JACKSON BUILDING DESIGN REVIEW RECOMMENDATIONS PACKET

5127 24th Avenue NE DCI Project #3019817 Meeting Type/Date: NA (ADR)

Section 8 Itemized Response to EDG

Section 7 Composite Site Plan

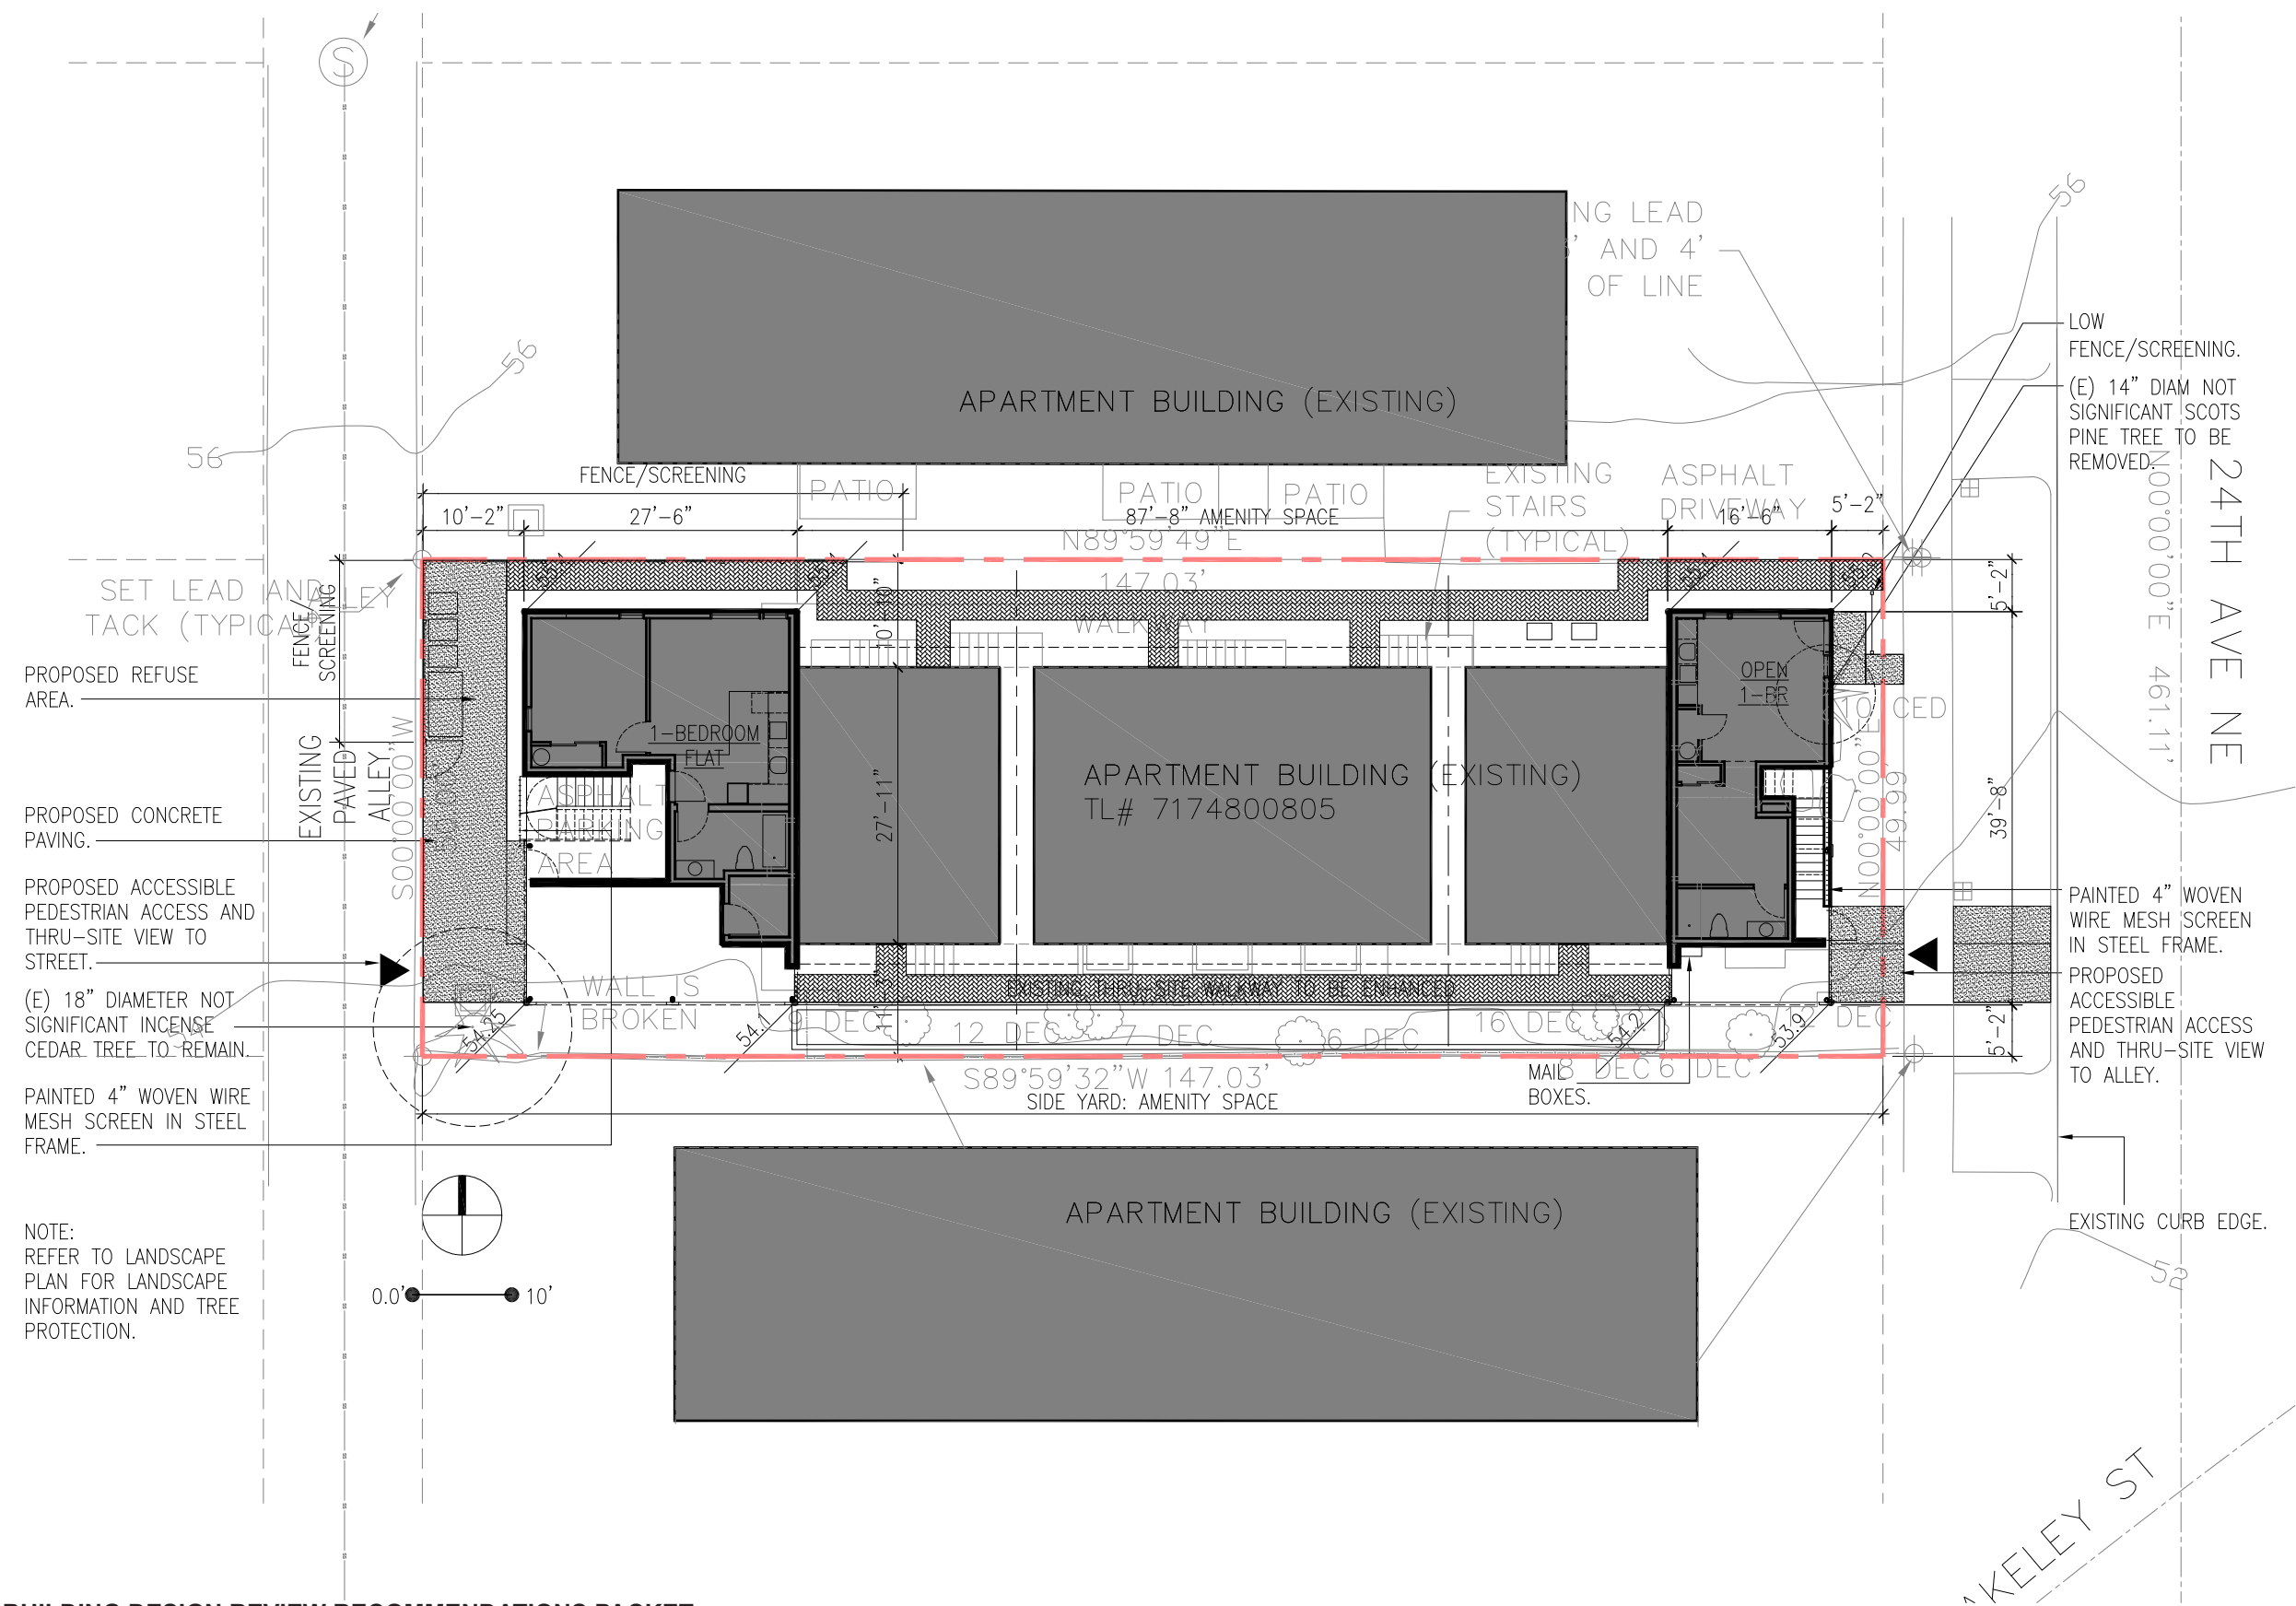
| ADR COMMENT # | DESCRIPTION | RESPONSE |
|---------------|---|--|
| 1A | RETENTION OF EXISTING LARGE TREE IS IMPORTANT IN THE RAVENNA URBAN VILLAGE. A SPRUCE TREE IS LOCATED NEAR THE SOUTHWEST CORNER OF THE SITE AND IS NOTED TO REMAIN. MAINTAIN THIS TREE INCLUDE ALL REQUIRED TREE PROTECTION AREAS ON ALL SITE AND LANDSCAPE PLANS, AND INCORPORATE IT INTO THE PROJECT DESIGN AND CONNECT TO THE EXISTING TREE CANOPY AREA | THE TREE SHALL BE MAINTAINED AND PROTECTED. IT IS INCORPORATED INTO THE CONCEPT INsofar AS IT FALLS WITHIN THE REAR YARD AND IS ADJACENT TO THE OPEN GROUND FLOOR AREA. |
| 1G | THE EXISTING SOLID WASTE/RECYCLE AREA IS LOCATED AT THE SOUTHWEST CORNER OF THE SITE, UNDER THE SPRUCE TREE. IT IS NOT CLEAR WHERE THE SOLID WASTE/RECYCLING AREA IS PROPOSED TO BE LOCATED. INCLUDE INFORMATION DESCRIBING THIS AREA, ENSURING IT IS NOT WITH THE TREE PROTECTION AREA OF THE SPRUCE TREE, AND THAT IT IS SCREENED AND INCORPORATED INTO THE STRUCTURE'S ARCHITECTURAL CONCEPT. ENSURE THE SCREENING AND LOCATION REDUCES POSSIBLE IMPACTS OF THESE FACILITIES ON BUILDING AESTHETICS AND PEDESTRIAN CIRCULATION | THE SOLID WASTE AREA HAS BEEN MOVED TO THE NORTHWEST CORNER OF THE SITE. |
| 1I | THE PACKET STATES THAT BICYCLE PARKING IS INTENDED TO BE LOCATED AT THE ENTRY PORTALS ALONG THE STREET AND ALLEY. PROVIDE INFORMATION DESCRIBING THE BICYCLE PARKING AREA, AND ENSURE THEY ARE INCORPORATED INTO THE ARCHITECTURAL CONCEPT. BIKE RACKS AND STORAGE SHOULD BE LOCATED TO MAXIMIZE CONVENIENCE, SECURITY, AND SAFETY. | MORE INFORMATION HAS BEEN PROVIDED ON THE PLANS AND ELEVATIONS. THE BIKE STORAGE AREAS ARE PART OF THE SOUTH COVERED THRU-SITE WALKWAY - A SIGNIFICANT PART OF THE ARCHITECTURAL CONCEPT. |

Section 10 Composite Landscape / Hardscape Plan

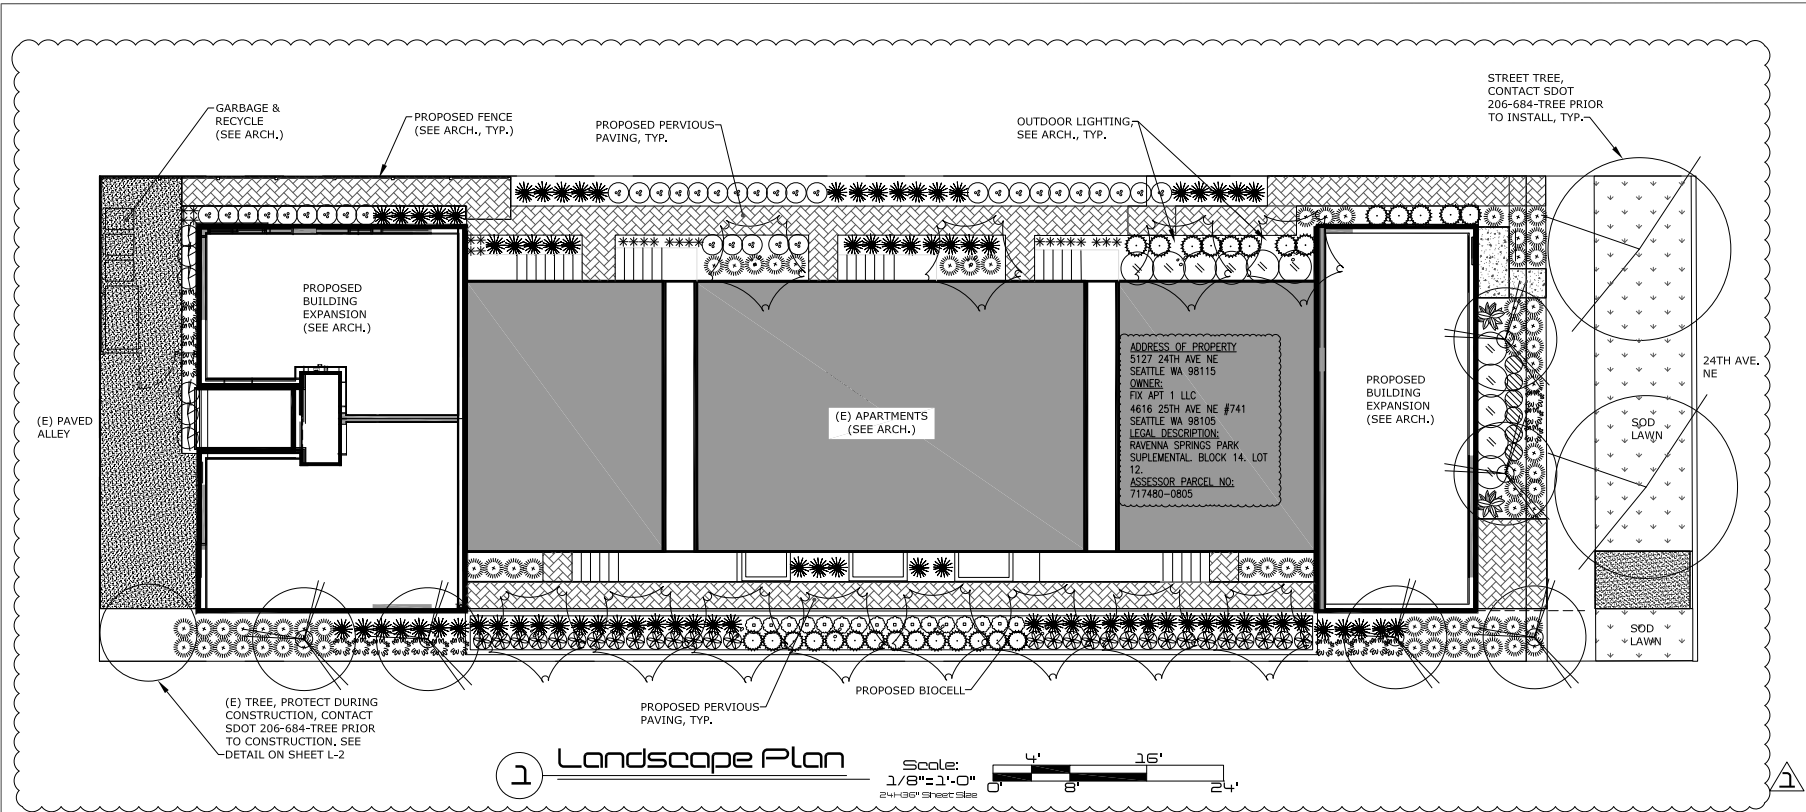
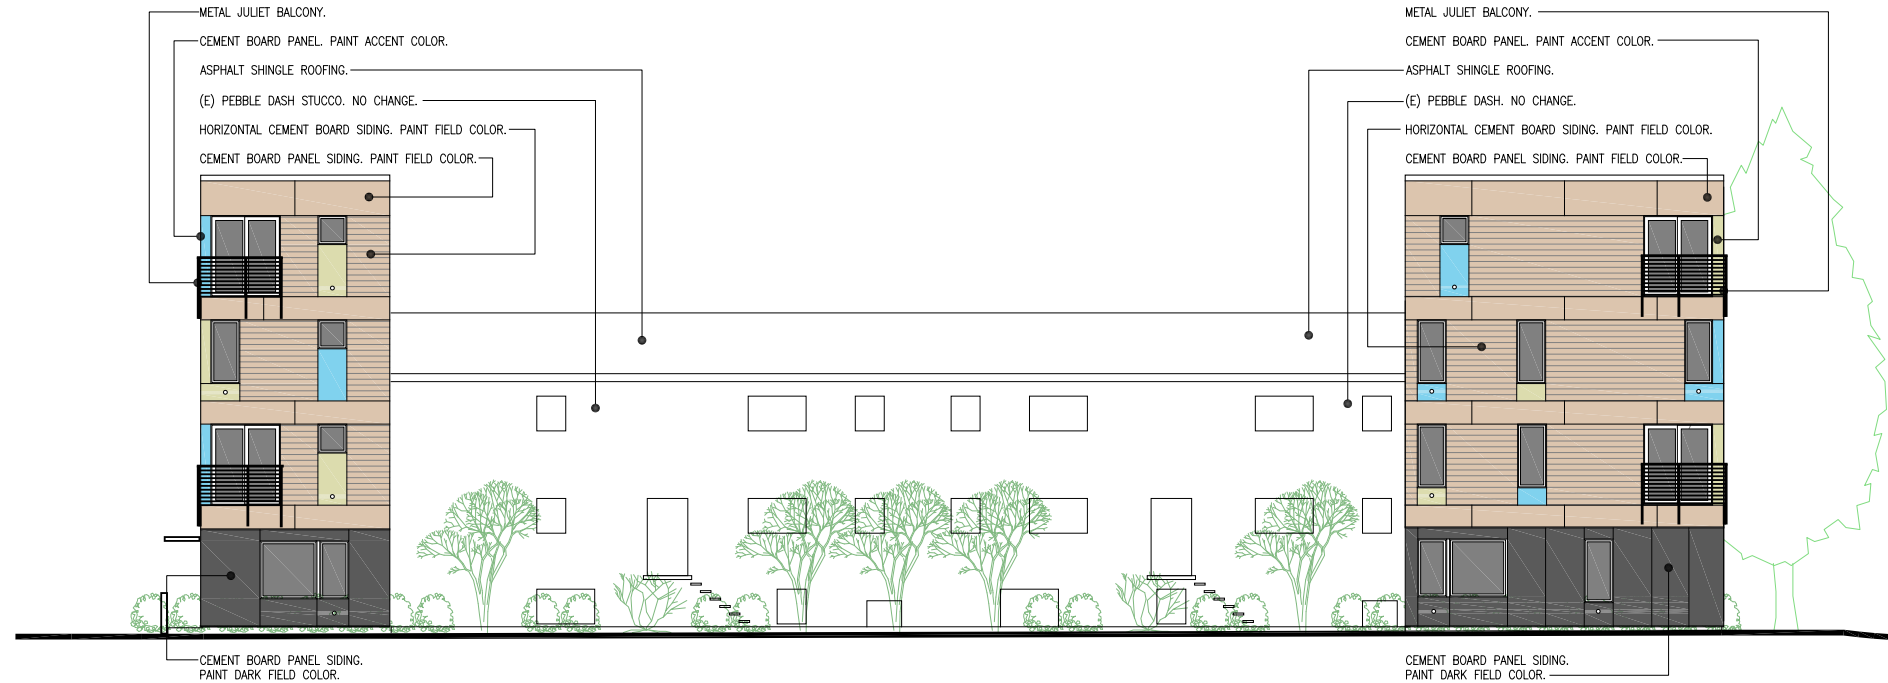
| ADR COMMENT # | DESCRIPTION | RESPONSE |
|---------------|---|--|
| 1E | THE PROPOSAL REMOVES LANDSCAPING WITHIN THE FRONT SETBACK. IT IS NOT CLEAR HOW THE PROPOSED FRONT SETBACK WILL BE TREATED. FURTHERMORE, THE EXISTING SITE MAY BE NONCONFORMING RELATIVE TO THE REQUIRED GREEN FACTOR. INCLUDE DETAILED LANDSCAPE PLAN INCLUDING THE REQUIRED CALCULATIONS DEMONSTRATING THE EXTENT OF THE NON CONFORMANCE, AND CONFIRM THAT THE PROPOSED ADDITION WILL NOT MAKE THE SITE MORE NON-CONFORMING (IN TERMS OF GREEN FACTOR). ADDITIONAL DESIGN REVIEW DEPARTURES WILL BE REQUIRED IF THE SITE'S NON-CONFORMANCE IS INCREASED. | A LANDSCAPE PLAN IS PROVIDED. THE PROJECT PROPOSES MEETING THE GREEN FACTOR REQUIREMENTS. |
